COUNCIL ASSESSMENT REPORT

Panel Reference	PPSSNH-575
DA Number	eDA0516/24
LGA	Ku-ring-gai
Proposed Development	Demolition works, tree removal, subdivision, lot consolidation and construction of a residential apartment development, including basement, landscaping and associated works.
Street Address	136 – 144 and 148 Fox Valley Road, Wahroonga
Applicant/Owner	Applicant: The Trustee for Capital Corporation Wahroonga 3 Unit Trust Owner: Australasian Conference Association Limited
Date of DA lodgement	3 December 2024
Total number of Submissions	Two
Number of Unique Objections	
Recommendation	Refusal
Regional Development Criteria Schedule 6 of the SEPP (Planning Systems) 2021	Estimated development cost of greater than \$30 million
List of all relevant s4.15(1)(a) matters	• Wahroonga Estate Concept Plan (MP07_0166) – MOD 9 (Concept Plan) • Environmental Planning and Assessment Regulation 2021 • Environmental Planning and Assessment (Savings, Transitional and Other Provisions) Regulation 2017 • State Environmental Planning Policy (Resilience and Hazards) 2021 • State Environmental Planning Policy (Biodiversity and Conservation) 2021 • State Environmental Planning Policy (Sustainable Buil

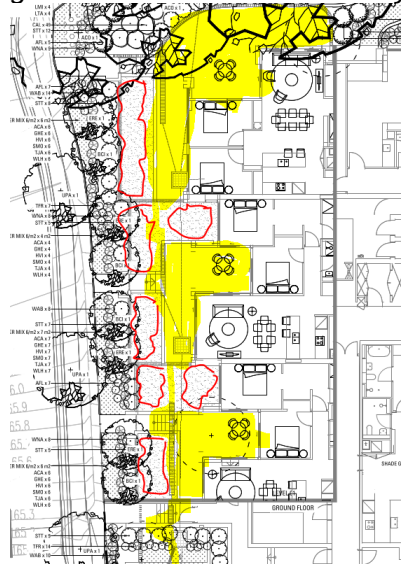
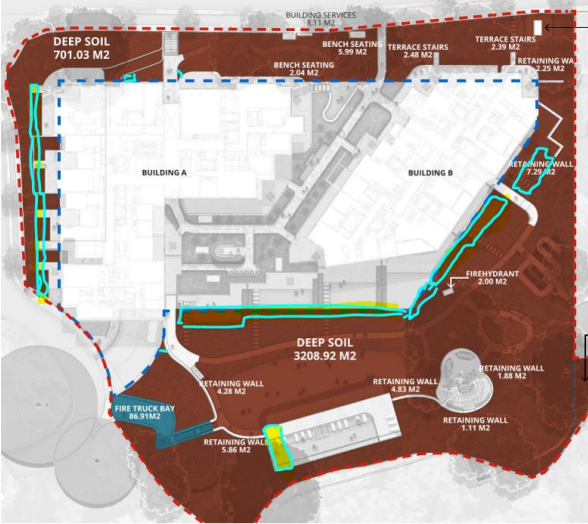
KDCP COMPLIANCE TABLE		
Control	Proposed	Complies
Part 7A.3 Building setback, 7A.6 Deep Soil Landscaping and Part 13 Tree and Vegetation Preservation		
Part 7A.6 Objective 1 To ensure landscape areas contribute to the garden character and canopy of the Ku-ring-gai locality. Deep soil landscaping is defined as the soft landscaped part of the site area that is; not occupied by any structure whether above or below the surface of the ground except for minor structures such as: paths to 1.2m wide, stormwater pipes of 300mm or less, lightweight	Site Area Minimum Deep Soil Landscaping Less than 1800^{m2} 40% of the site 1800^{m2} or more 50% of the site The proposal does not satisfy this part. Site Area – 8205m² 50% deep soil requirement based on 8205m² – 4135.655m². Deep soil stated on plan as 4258m² including slip lane and 3956m² (48.2%) excluding slip lane, however deep soil plan provided is incorrect as includes the following areas as deep soil that are not under the deep soil definition. - Inclusion of private open space to ground floor units to east, west and south, rather than within common areas. - Area less than 2m width and paths more than 1.2m wide Slip lane (301.8m²) is not considered for inclusion. Actual approximate deep soil area from my	NO

calculations is **approximately 3562m² (43.4%)**

- To western ground floor units delete turf and move courtyard fences to limit private open space to area within line of proposed paved courtyards and over basement-67m² approx.
In addition, a wider deep soil area will allow for a larger tree to be provided to western boundary plus the retaining walls located with greater setback from boundary.

- Southern and eastern courtyards to be restricted to line of basement. An additional 157.5m² approx. could be added to deep soil.

- Pool reduced to 15m in length then 42m² approx deep soil available or if pool deleted approx 207m² deep soil available.

Reduction of private courtyards to line of courtyards/basement under and reduction in pool would result in approximately 3828.5m² (46.7%) based on my calculations of current deep soil at 3562m². Deletion of pool plus reduction of private courtyards to in line with basement would result in approximately 3998.5m² (48.7%). 	
Part 7A.6 Control 2. Deep soil zones are to retain healthy and significant trees where possible	Three trees are proposed for retention on site, Tree 108 <i>Eucalyptus saligna</i> (Sydney Blue Gum), and 109 <i>Syncarpia glomulifera</i> (Turpentine) and Tree 134 <i>Platanus x hispanica</i> (Plane tree) to south-western corner. Trees 108 and 109 are in poor condition and recommended for removal in Arborist report due to 50% crown dieback in T109 and codominant stems at 8m with one dead to T108 however removal triggers BDAR and trees are indicated to be retained Tree 107 <i>Eucalyptus saligna</i> (Sydney Blue Gum) to the western boundary within neighbouring lot. Trees 1, 2, 3, 10, 13, 14, 15, 16, 17, and 19 are approved for removal under the road widening works for the intersection. Trees 4, 5, 6, 7, 8, 9, 11, 12, 20, 21, 22, 24, 25, 111 – 117 removed due to building works and level changes. Trees 6, 7, 25, 110, 118, 119 120 removed due to proposed level changes within landscaping and exempt species (T25) Trees to be retained. Trees 104, 105 within planting bed to the west of the entry road. Tree 107 to the south of the proposed fire truck parking Trees 108, 109 and 134 on site	YES

Figures 14 and 15: Proposed variations to the approved building envelopes

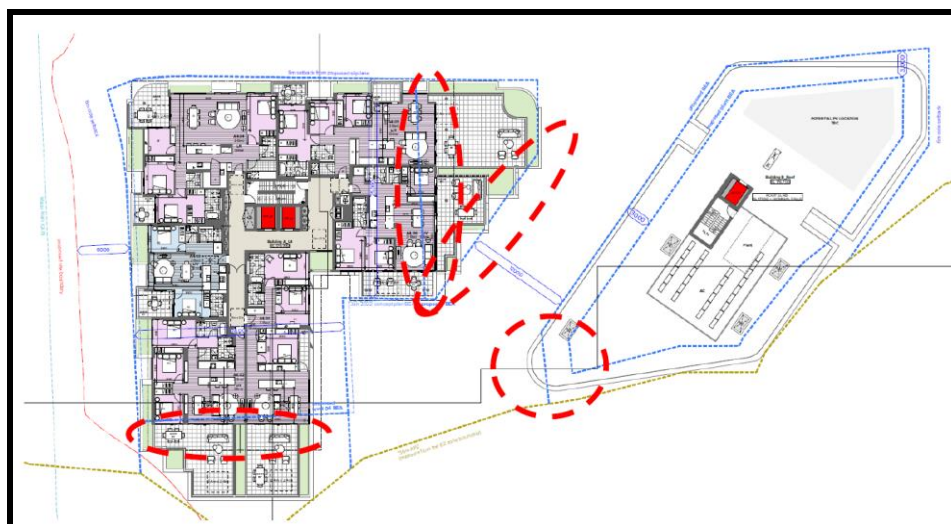
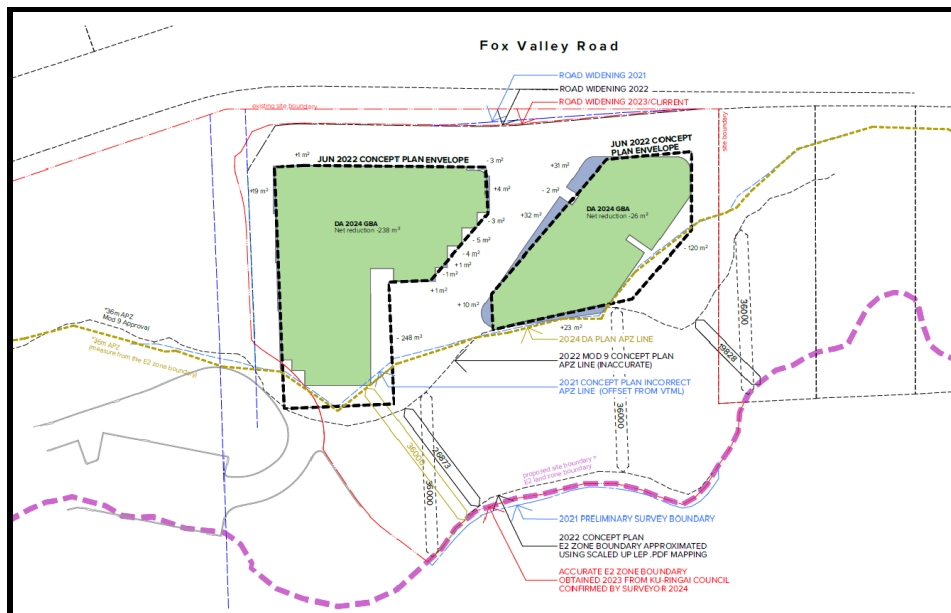
The proposal seeks a variation to the building envelope stipulated in Condition B1(1) (Figures 14 and 15).

Building A: Internal building separation

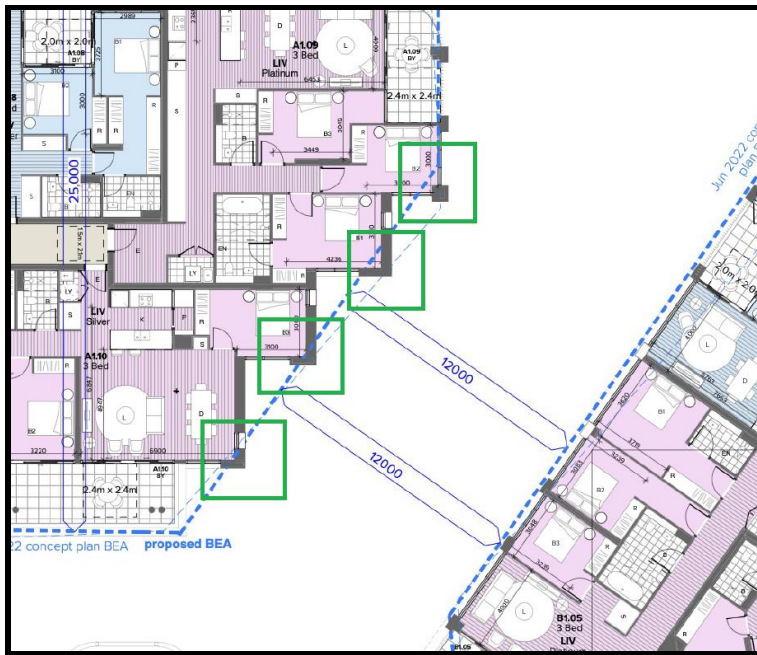
The eastern façade of Building A is stepped and encroaches up to 1.7m into the

approved 12m internal building separation required under the Concept Approval.

Building B: south-west facing balconies on Levels 1, 2 and 3

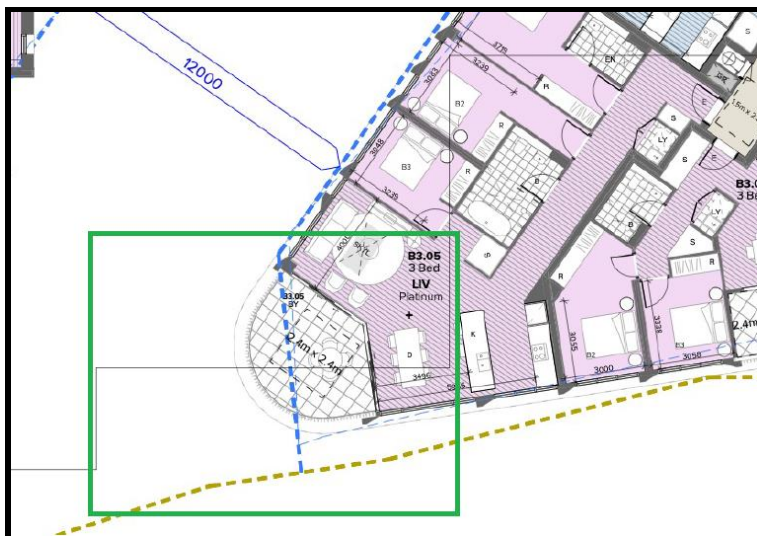
A portion of the south-west facing balcony of Unit B3.04 extends a maximum of 2.4m beyond the approved building envelope.

Building A: southern portion of building on Level 4

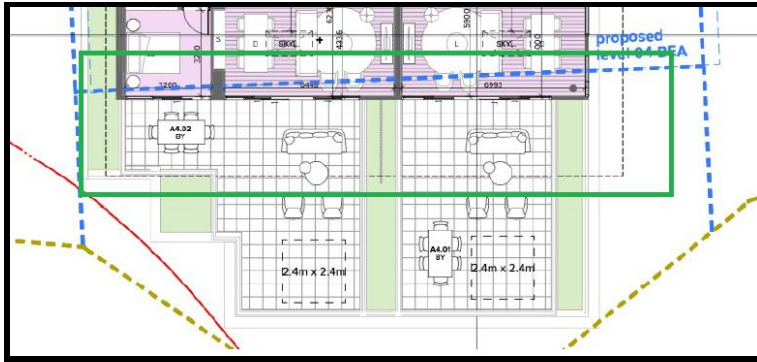
A portion of the habitable area, balconies, roof and eaves on Level 4, Building A, encroaches beyond the approved building envelope to the south.

Building A: eastern portion of the building on Level 4

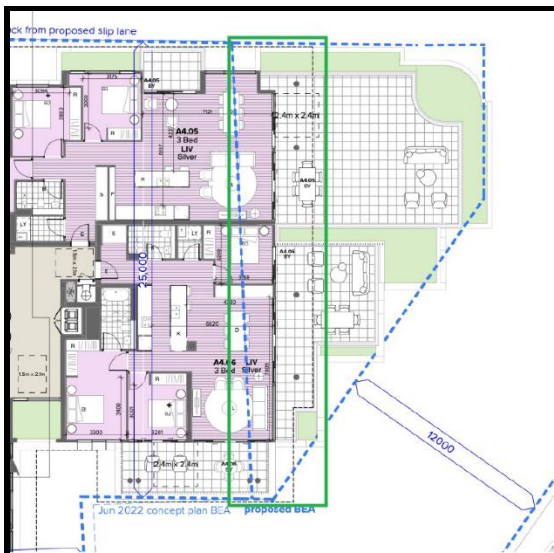
A portion of the habitable area, roof and eaves on Level 4, Building A, encroaches beyond the approved building envelope to the east.

Figures 19 and 20: Site Plan and Lower Ground Floor Plan detailing proposed AZP from zone and site boundary (Source: Updated Bushfire Protection Assessment, Issue date 08.05.2025; Prepared by Australian Bushfire Protection Planners Pty Ltd)

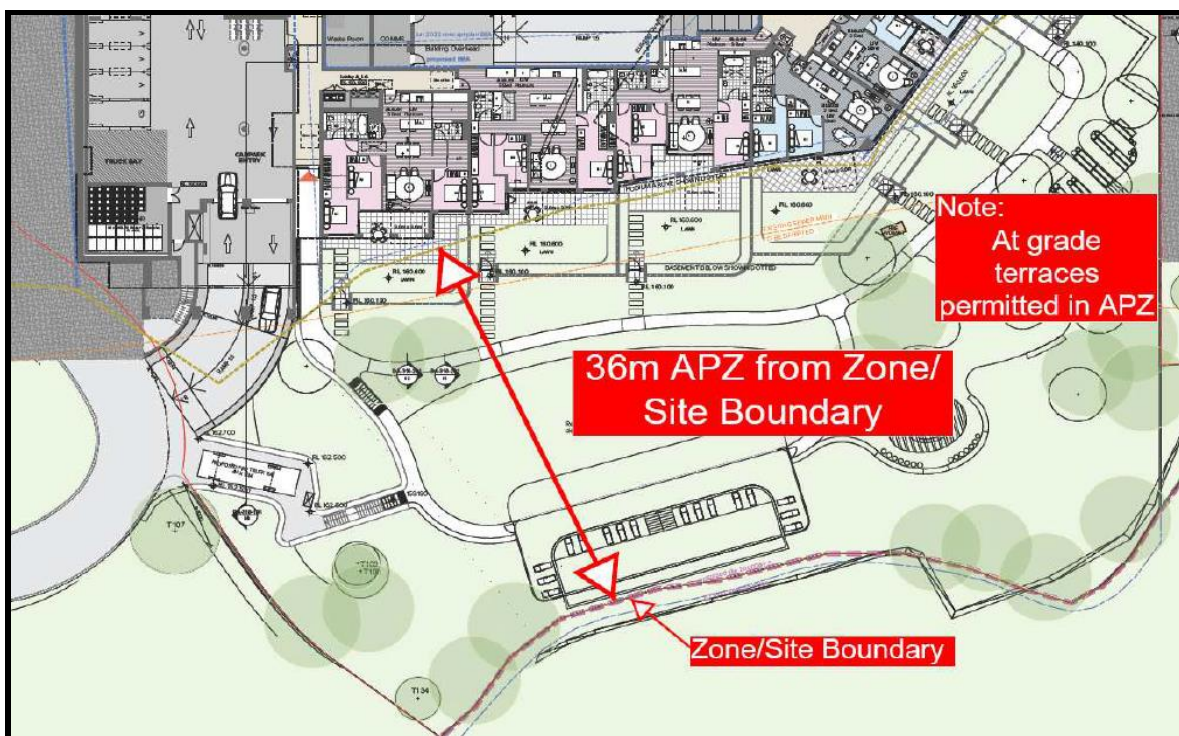
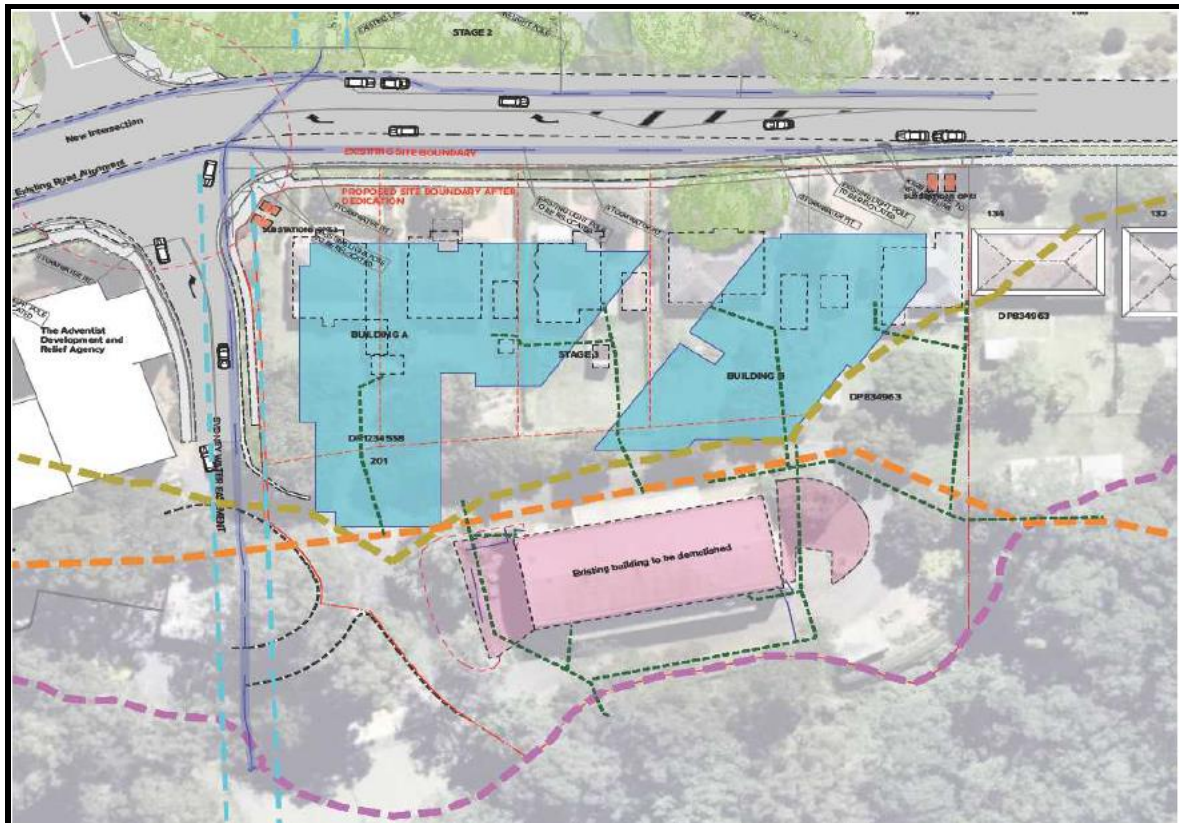
The proposal seeks to modify the approved APZ line, with the applicant justifying the variation on the basis that the APZ line in the approved Concept Plan was incorrectly plotted.

The approved plans supporting the Concept Plan (Mod 9) contained the following errors:

- The boundary of the E2 Environmental Conservation (now designated as the C2 Environmental Conservation Zone) was inaccurately plotted;
- As a result, the APZ line was also incorrectly shown as being 36 metres from the misaligned E2 zone boundary.

As detailed in **Figure 20**, the site boundary to the south is represented by a dashed red line, which aligns with the C2 Environmental Conservation zone, represented with a thick dashed purple line. The proposed amended APZ line is offset from the accurate site boundary and the C2 zone boundary by 36 metres.

Figure 21: proposed dispersion trench is located on the adjoining property, which is zoned C2 Environmental Conservation

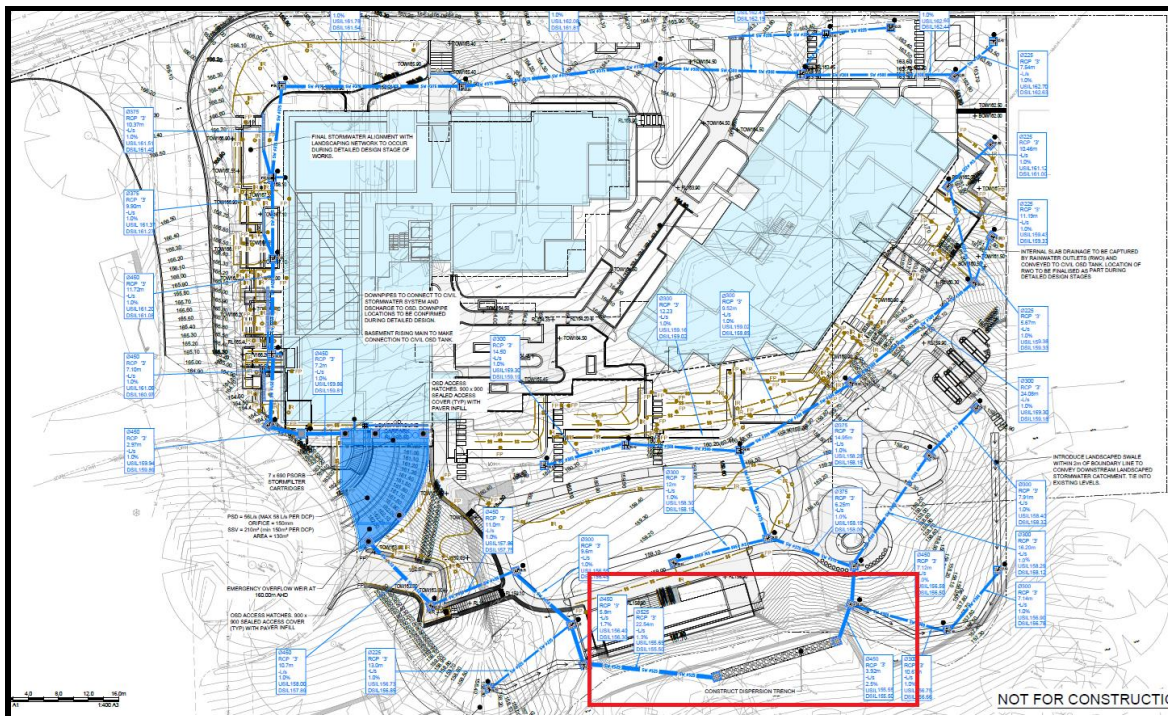
boundary, which is zoned C2 Environmental Conservation (**Figure 21**). The objectives of the C2 zone are:

Stormwater drainage works are a prohibited form of development within the C2 Environmental Conservation zone. Pursuant to section 4.3 'Development that is prohibited' of the Environmental Planning and Assessment Act 1979 and the zoning table for the C2 zone in KLEP 2015 consent for prohibited development cannot be granted.
